DATE: June 1, 2017
TO: Members of the Planning Commission and Interested Parties
FROM: Lisa Gibson, Environmental Review Officer
Re: **Attached Responses to Comments on Draft Environmental Impact Report Case No. 2009.0159E, 1500 Market St. (One Oak)**

ONE OAK STREET PROJECT

(1500-1540 MARKET STREET)

CITY AND COUNTY OF SAN FRANCISCO
PLANNING DEPARTMENT: CASE NO. 2009.0159E

(NEW) FIGURE 2.17: REVISED OAK PLAZA, PLAN

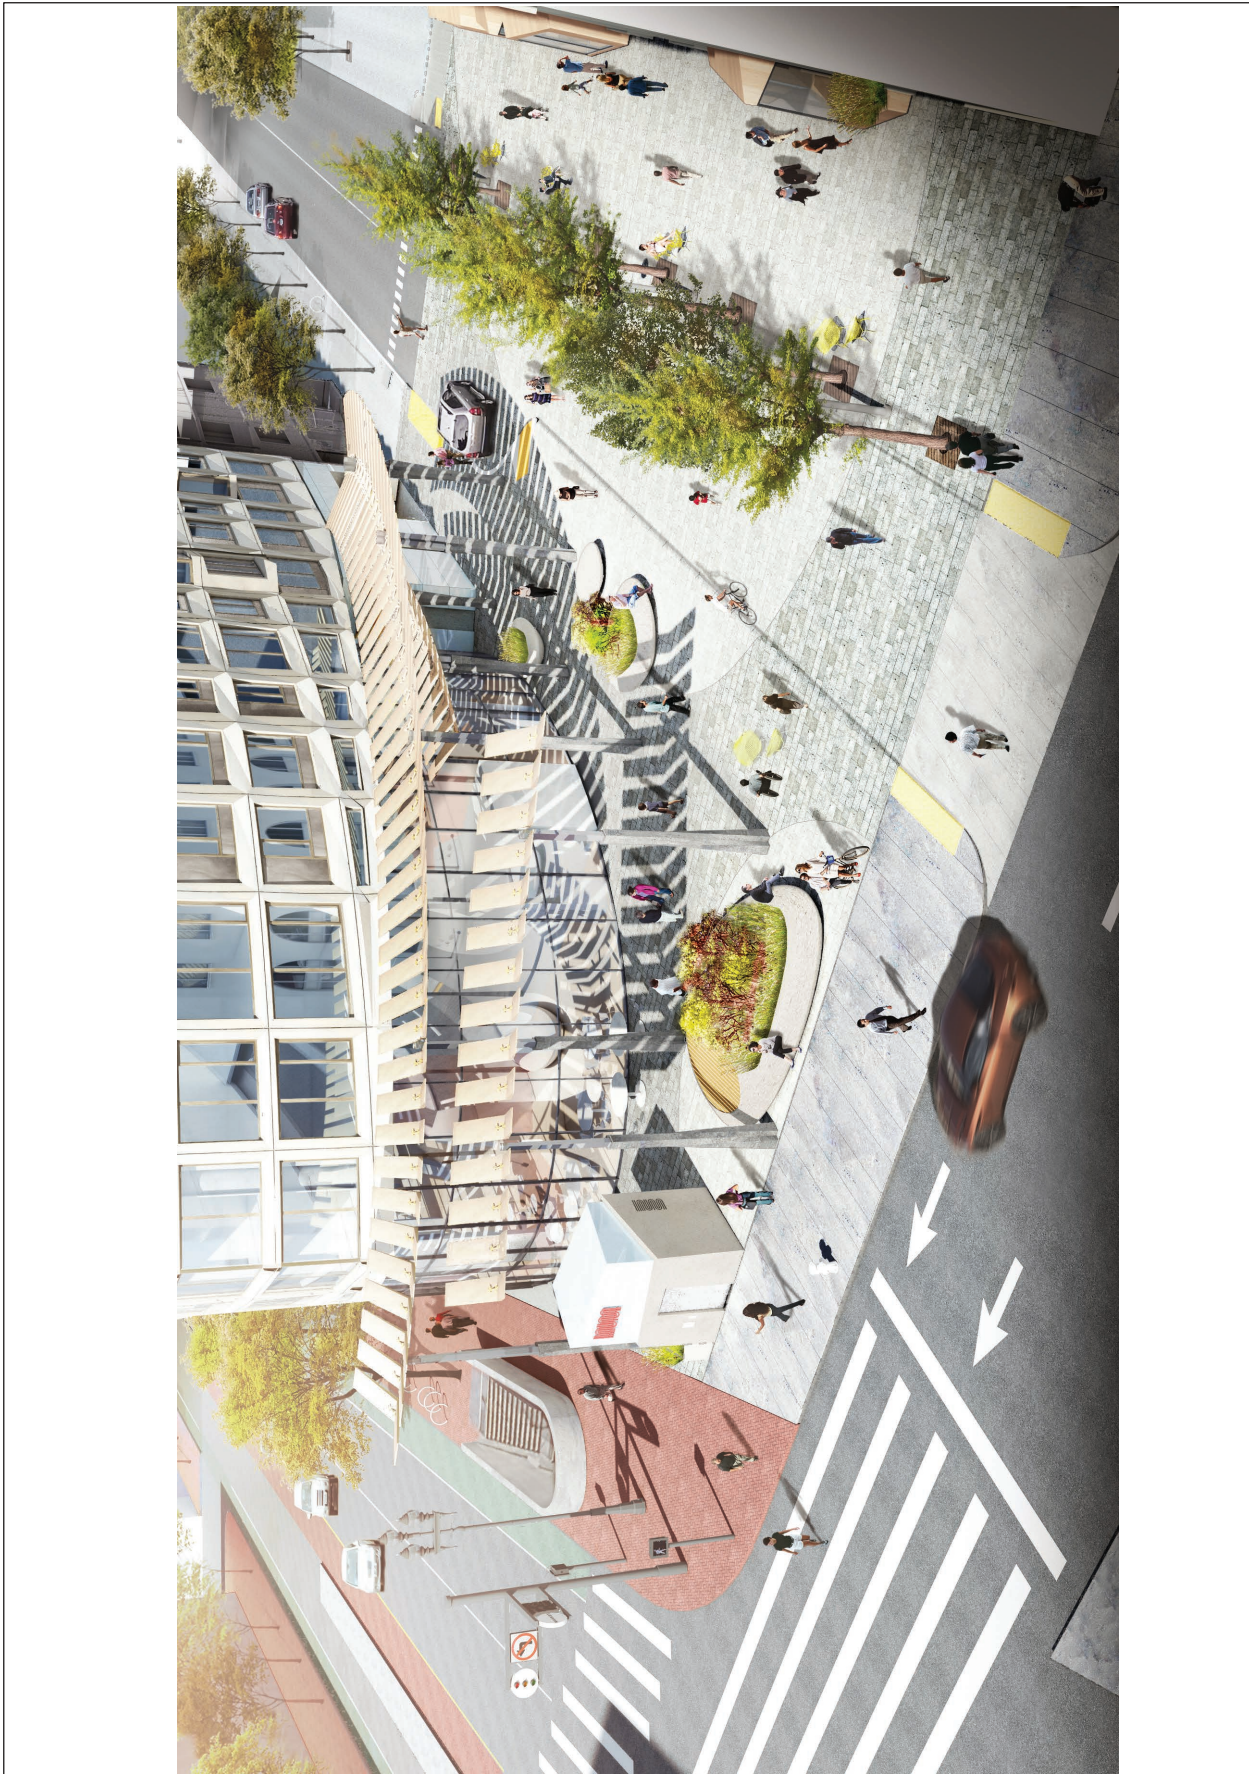
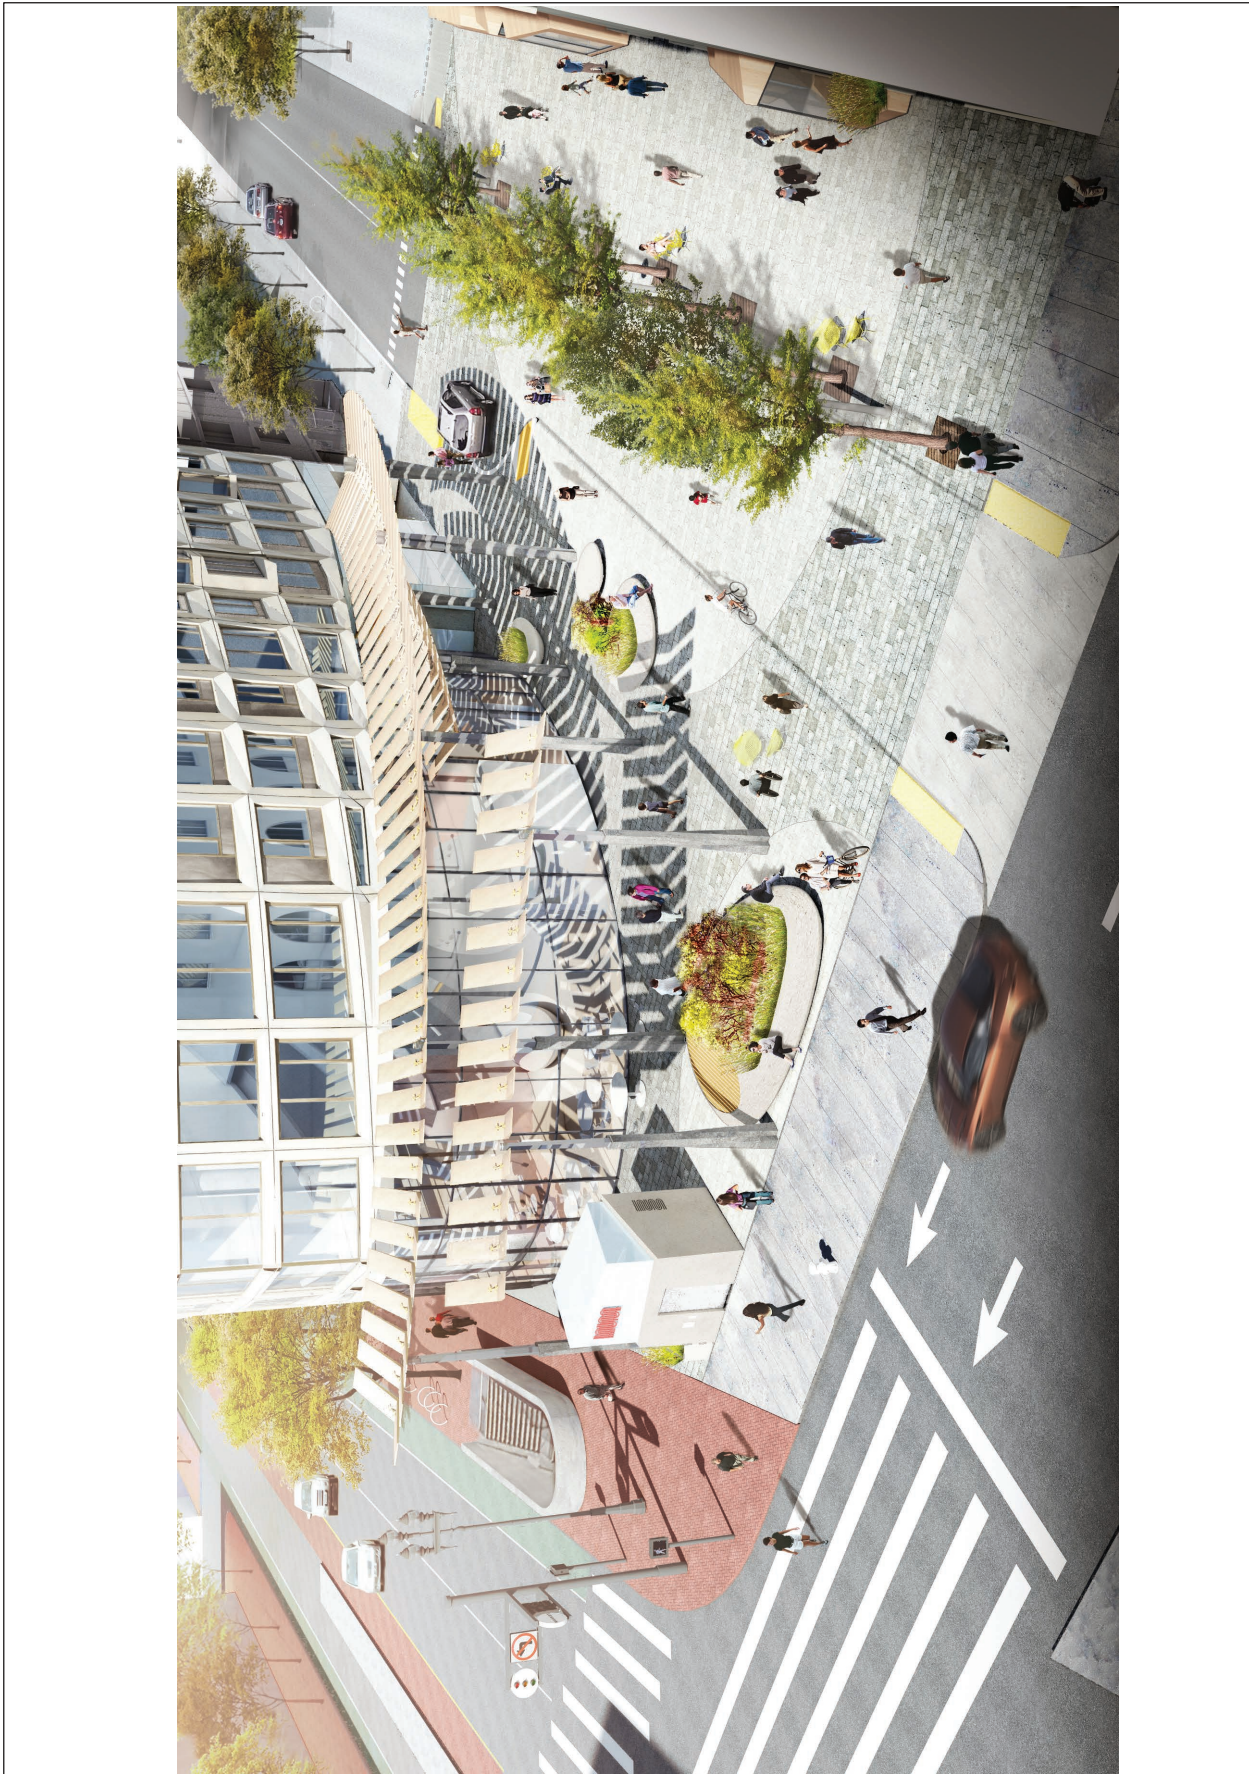
The design of the Oak Plaza wind canopies has been revised under the preferred project. See new Figure 2.17 on RTC p. 2.4. The revised canopies under the preferred project would consist of

three freestanding pergola-like structures comprised of perforated metal blades, each forming a broad, wing-like “V,” suspended along a central spine supported by vertical columns. In plan view, the blade coverage would be up to 75 percent porous, including the spaces between the blades. Two of the canopies would generally follow the curve of the tower base, while the third canopy would have an opposing converse curvature, rising in height from 18 feet above the Oak Street lobby entrance to 30 feet at the Market Street property line.

FIGURE RTC-1: AREA PLANS AND PLANNING AREAS NEAR THE ONE OAK PROJECT SITE

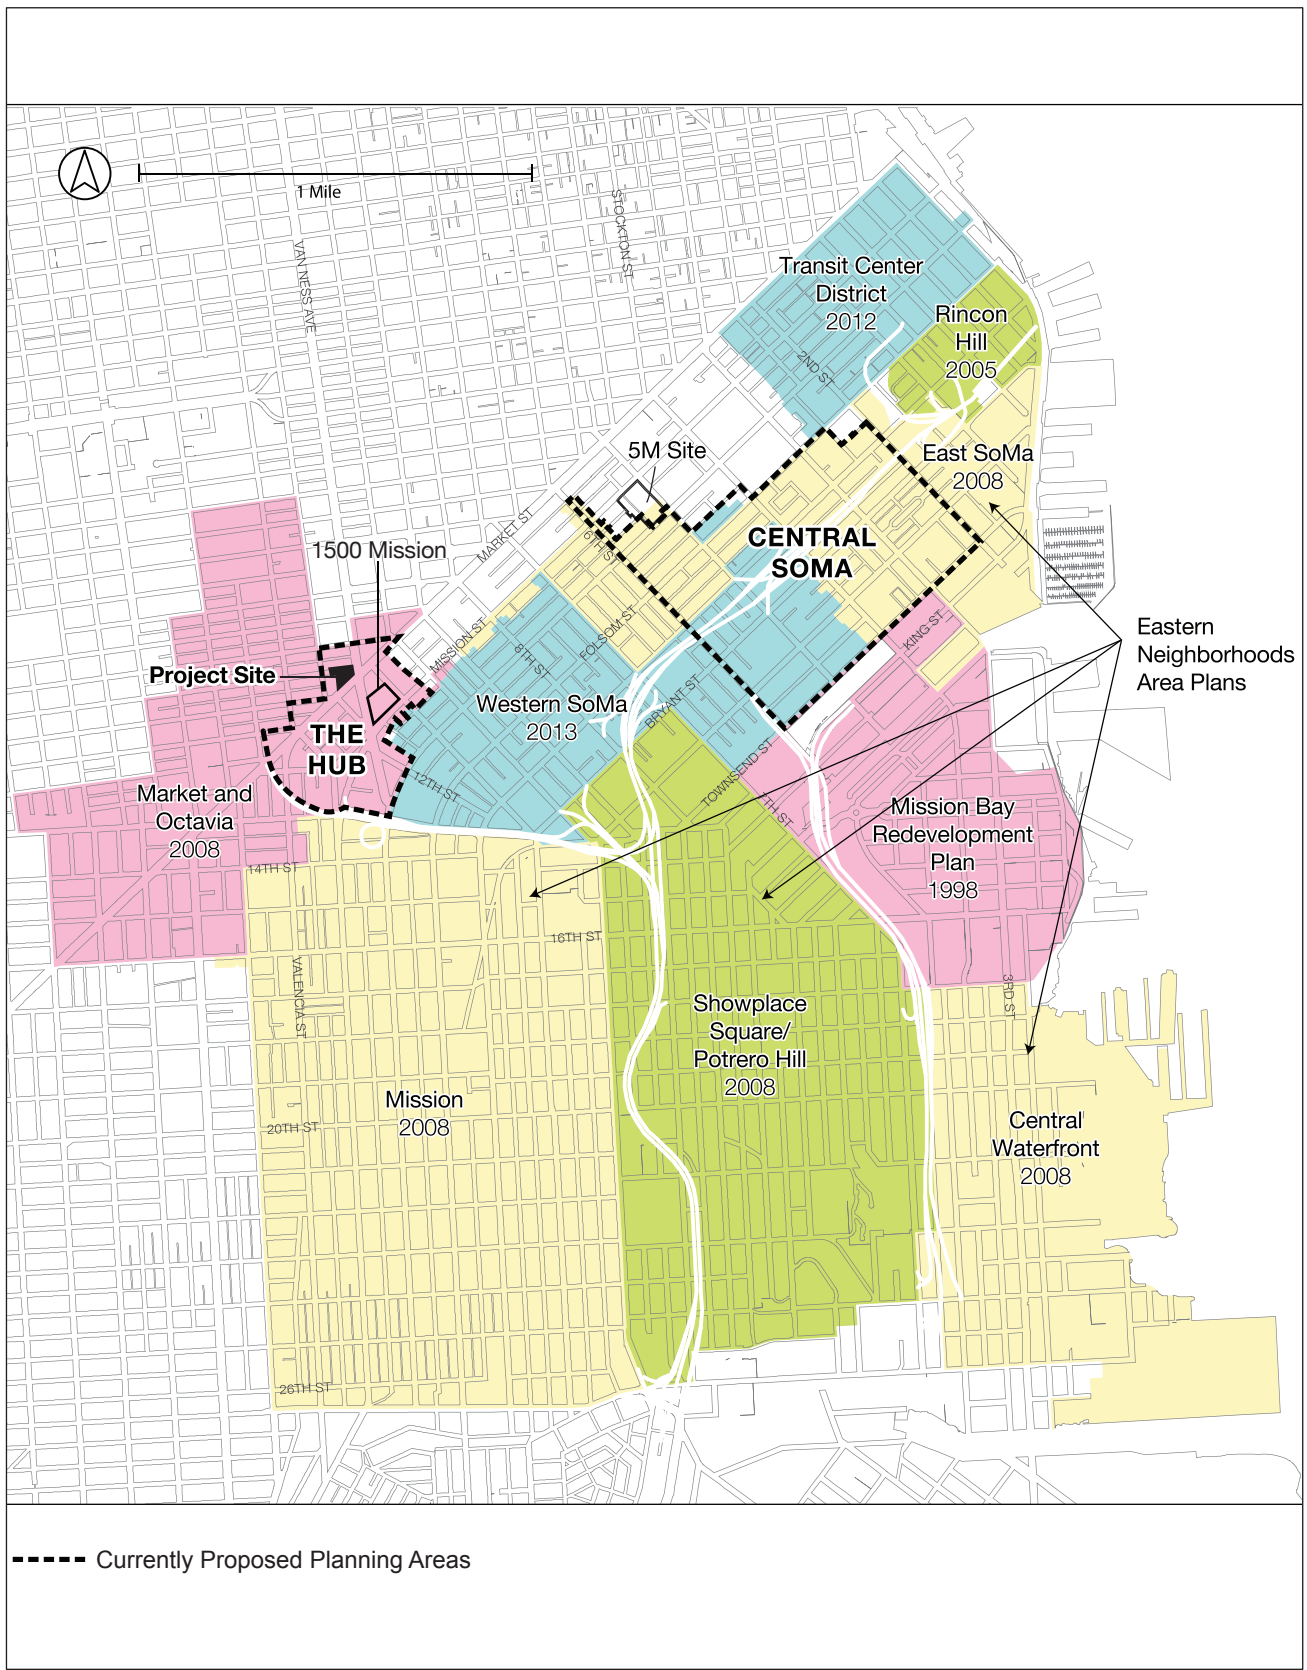
Figure RTC-1: Area Plans and Planning Areas Near the Oak Street Project Site, shows the recently adopted area plans, including the Market & Octavia Area Plan (adopted in 2008), the four Eastern Neighborhoods plans (Mission, Showplace Square/Potrero Hill, Central Waterfront, East SoMa) (adopted in 2008), the Western SoMa Plan (adopted in 2013), Rincon Hill Plan (updated plan adopted in 2005), and Transit Center District Plan (adopted in 2012). The figure also shows the area of the proposed Central SoMa Plan and the area covered by the proposed Hub planning effort. The nearby-proposed (1500 Mission Street Project, Case No. 2014-000362ENV) site is also shown, as is the approved 5M Project site. Each of these plans contains parking maximums, rather than parking minimums.

The EIR’s analysis of Land Use is adequate under CEQA because a sufficient description of existing uses was provided to establish that the addition of the proposed uses would not result in a significant land use impact applying the applicable significance thresholds. The inclusion of the requested additional details about the MO Plan, the *Western SOMA Plan*, the Van Ness and Market Downtown Residential Special Use District, the proposed *Central SoMa Area Plan*, required residential parking in the area, and the proposed Hub Project is not necessary for an

FIGURE RTC-2: REGIONAL FREEWAY FACILITIES

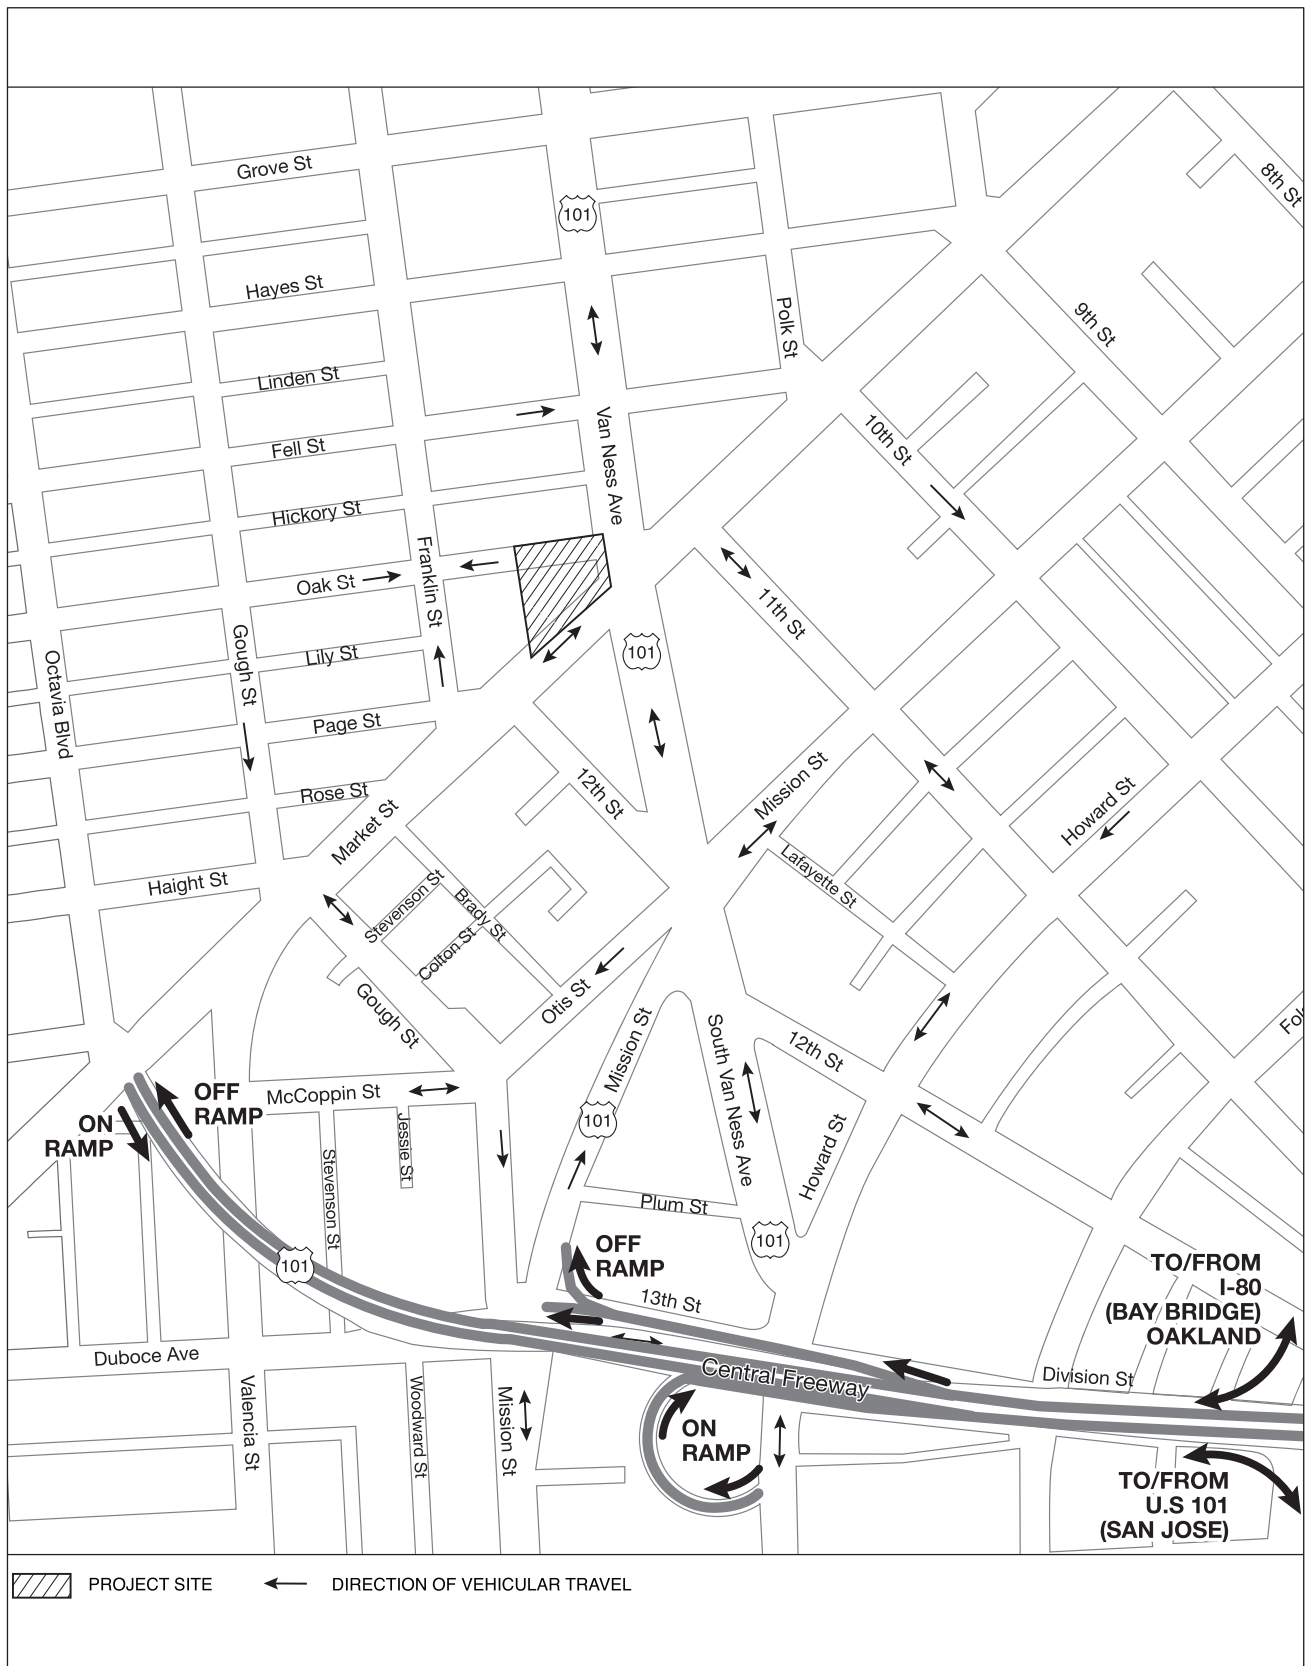
“A MAP of the freeway access and ramps will help understand travel patterns and possible impacts. And direct attention to the excessive parking provided in this "TRANSIT RICH" area. There is a freeway off ramp AT THE CORNER to the right of the Planning Department. There is an on ramp at South Van Ness and 13th. There is a Central Freeway ramp BEHIND the Planning Department. (*Sue C. Hestor, Letter, January 10, 2017 [I-Hestor2-4]*)

The comment requests a map presenting the nearby freeways access ramps. **Figure RTC-2: Regional Freeway Facilities**, presented on the next page, identifies the regional freeway connections in the vicinity of the project site. The project site is about 1,600 feet east of the U.S. 101 ramps at Octavia Boulevard, 1,900 feet north of the U.S. 101 off-ramp at Mission Street, and 2,200 feet north of the U.S. 101 on-ramp at South Van Ness Avenue. Access between the project site and the freeway facilities is described on EIR pp. 4.C.1-4.C.2, and therefore the EIR text does not need to be amended to state that the freeway ramps are used to enter and exit San Francisco.
